Architectural Review and
Historic Preservation Board
Agenda Report

Meeting Date 03/06/2024

File: AR 23-07

RE: Architectural Review 23-07 (New Smile Now)
3008 Cohasset Road; APN 015-070-010

1 - SITE PLAN
SCALE: 1" = 10'-0"

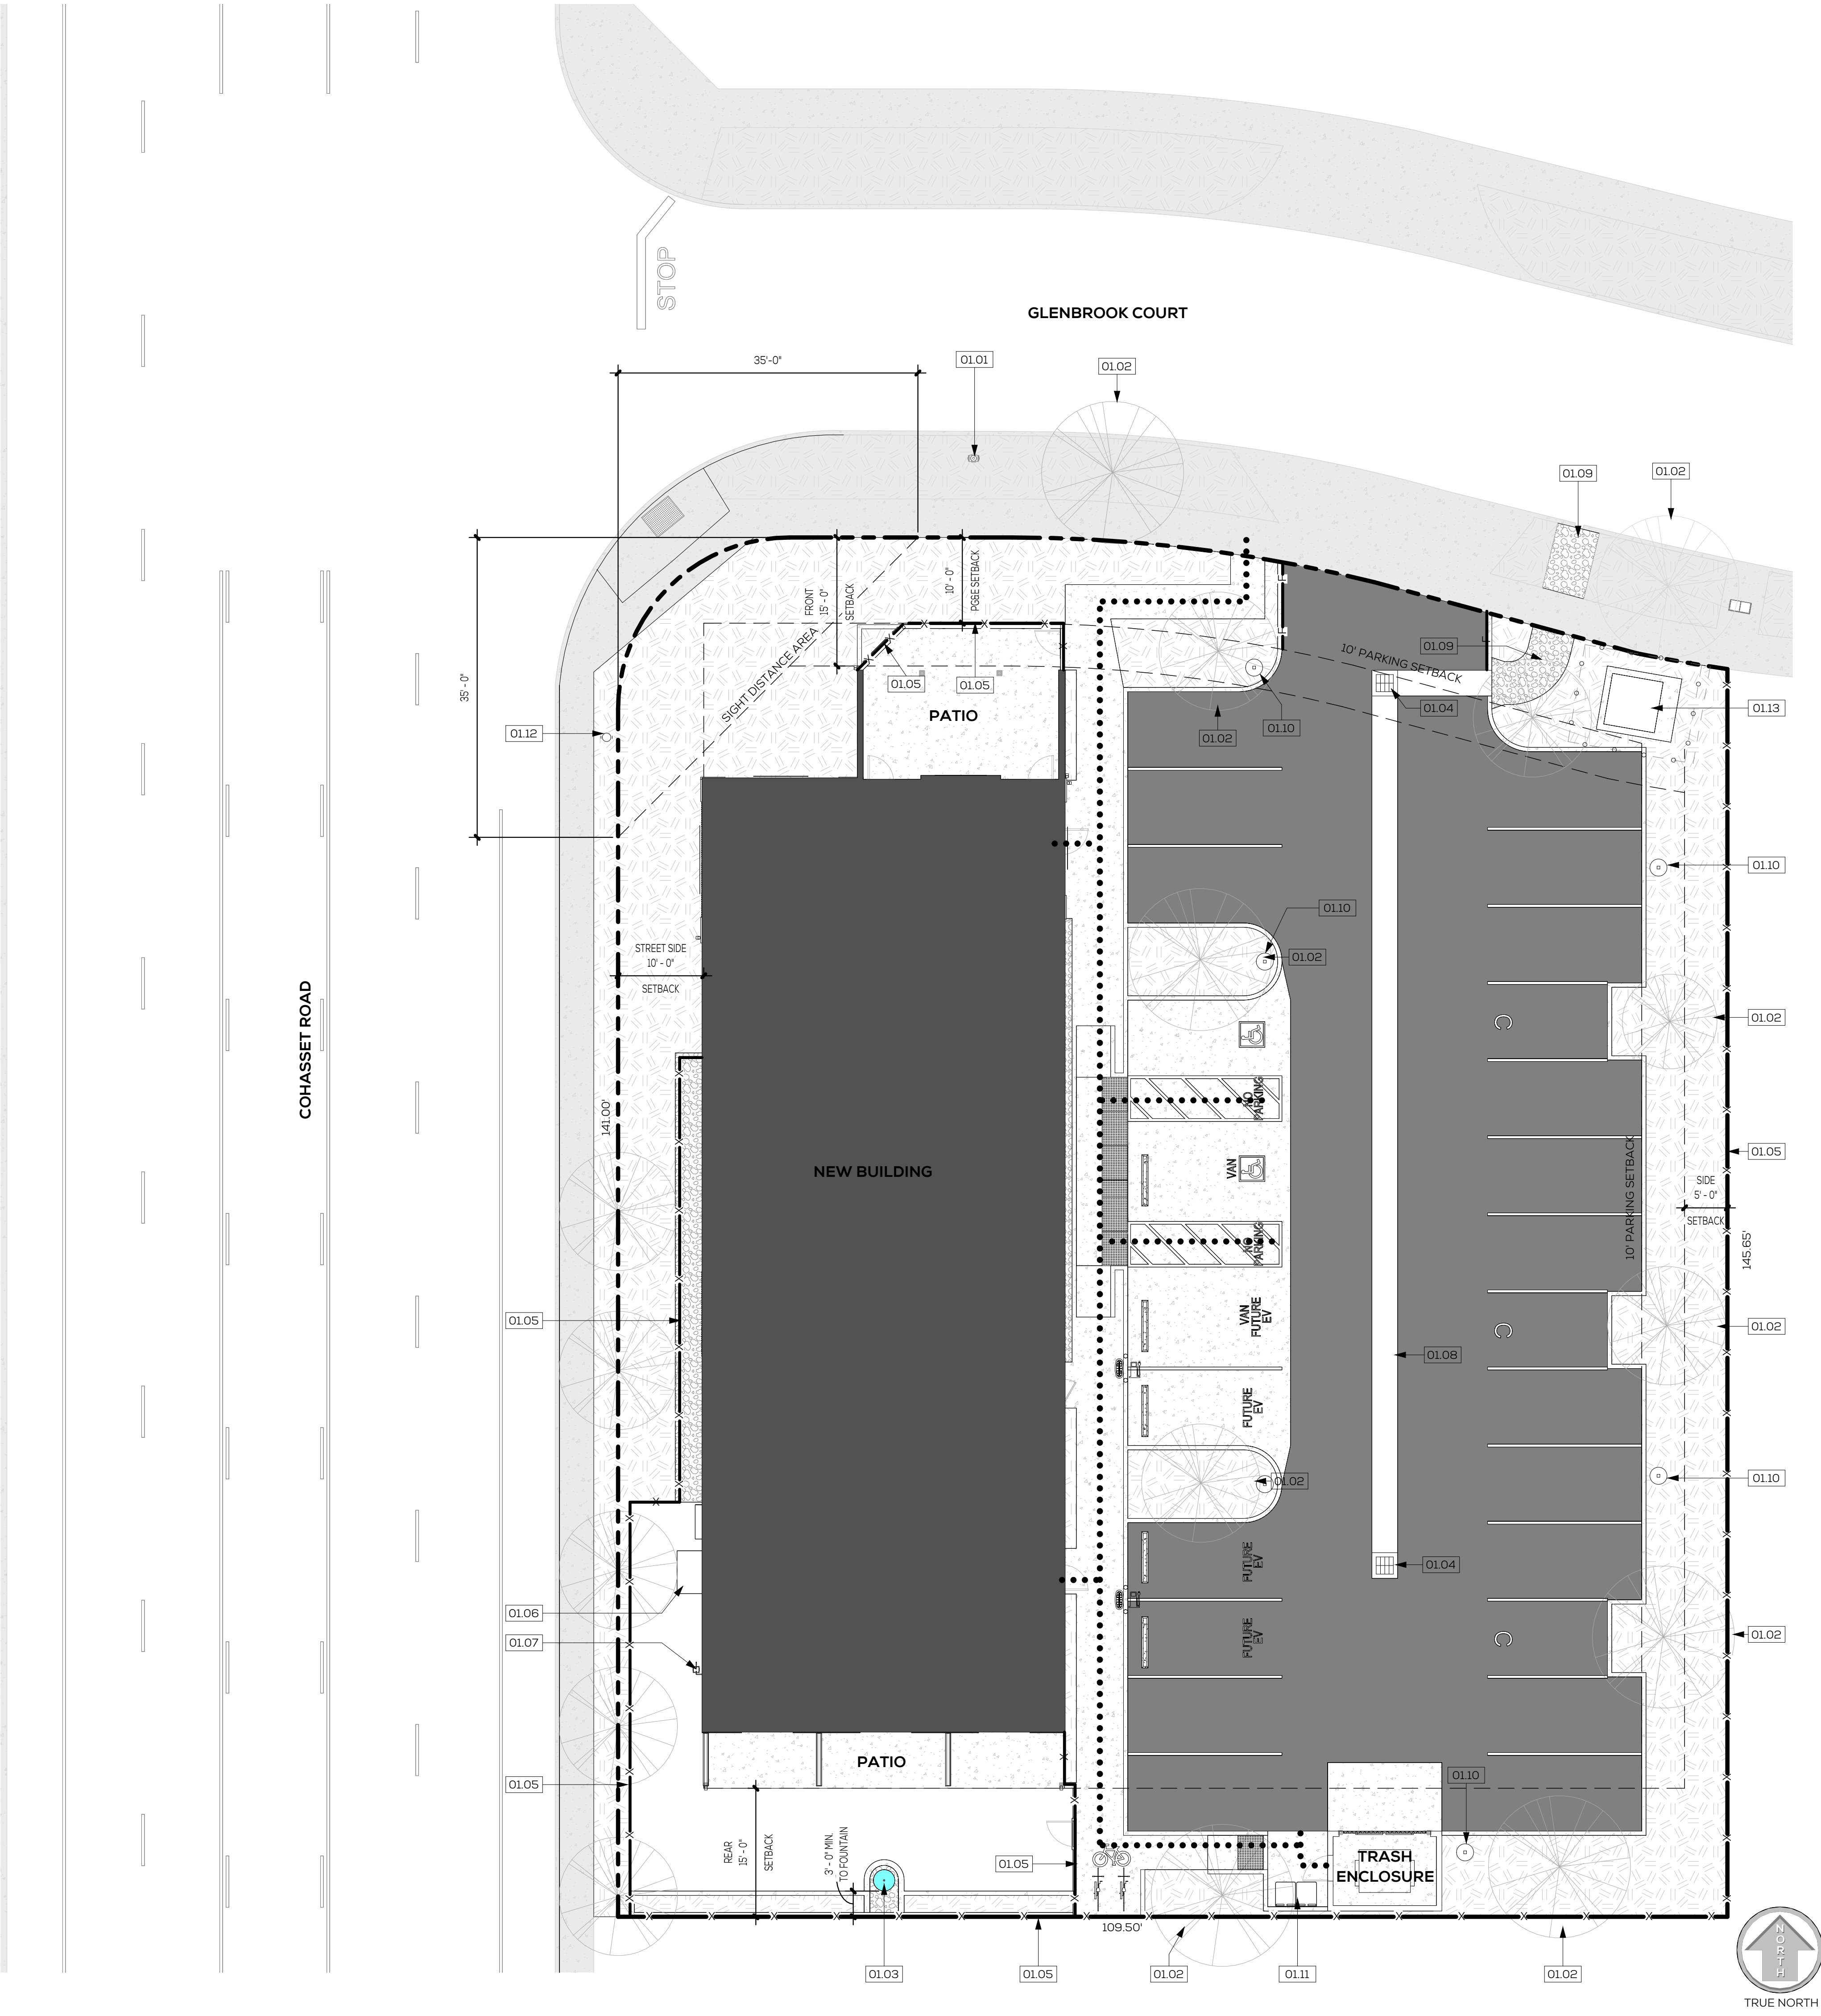
Currently the site proposes 25 parking spaces. Per Chico Municipal Code (CMC) 19.70.040.H. Table 5-4, dental offices are required to be parked at 1 space for each 250 square feet of gross floor area and offices are required to be parked at 1 space for each 375 square feet of gross floor area. Based on the assumed rates and total square footage of each proposed suite, the project is under parked by two spaces.

The applicant proposes to meet parking requirements through a shared parking agreement with the St. Cyril and Methodius Orthodox Church located next door (see **Attachment I**, Parking Agreement). Per **Condition #8** a pedestrian pathway between the two properties would be required to support joint use of the church's parking area. To satisfy the conditions of a non-residential shared parking reduction (CMC 19.70.050.B.) an additional deed restriction will be required to be recorded before issuance of a Certificate of Occupancy for the building (**Condition #9**).

8. A walking path through the shared fence between the office at 3008 Cohasset Road (APN 015-070-010) and church at 2956 Cohasset Road (APN 015-120-032) shall be installed prior to the issuance of a Certificate of Occupancy.

9. Prior to issuance of building permits, the permittee shall provide proof of a recorded parking agreement between 3008 Cohasset Road (APN 0015-120-032) and 2956 Cohasset Road (APN 015-070-010) demonstrating that the property at 3008 Cohasset Road is provided use of two off-street parking spaces from 2956 Cohasset Road, and provide a recorded copy to Planning Staff.

1 - WEST ELEVATION

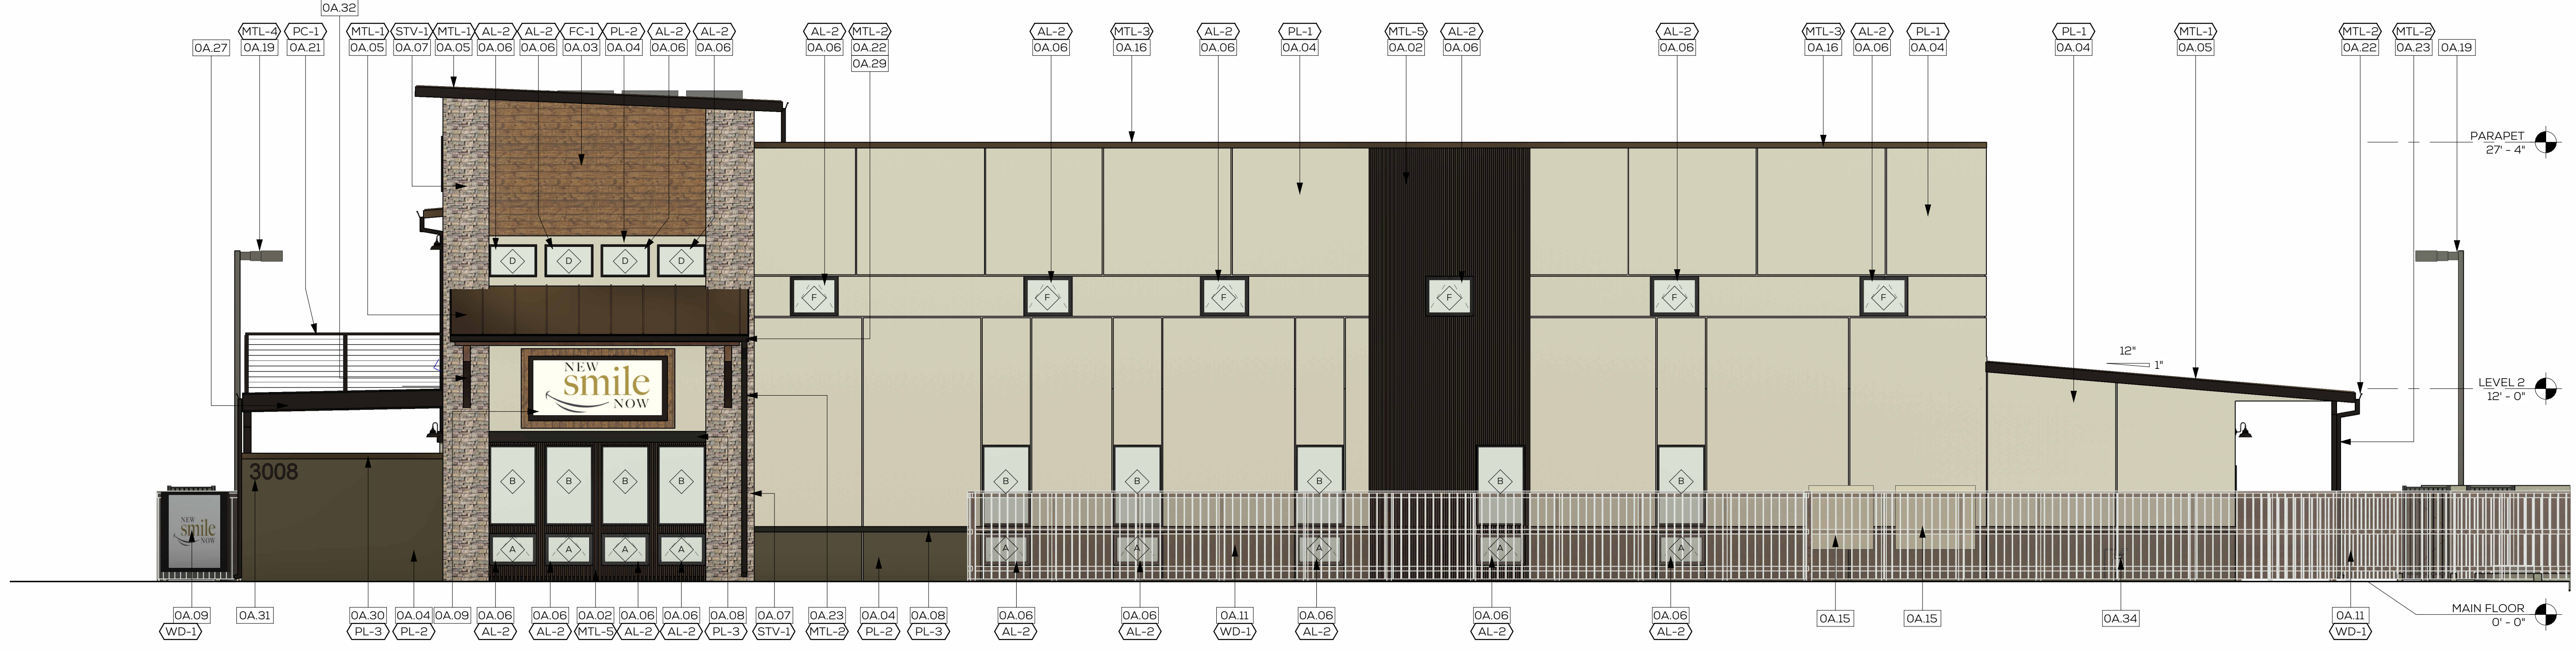
- Detailed information on what services will be provided within the new building and how the site will operate to confirm the correct parking ratio is applied.
- An internal layout of the building that supports the information requested above.
- “Absorption of the brown wall” along Cohasset Road to include additional articulation and/or fenestration.
- Further screening for the HVAC units.

The applicant has also provided a new western elevation along Cohasset Road that includes the addition of a metal vertical-seam siding (see **Attachment C**, Revised Elevations). In addition, ground level perspective (see **Attachment H**, Perspective) drawings are included to demonstrate how HVAC units would be shielded from street view.
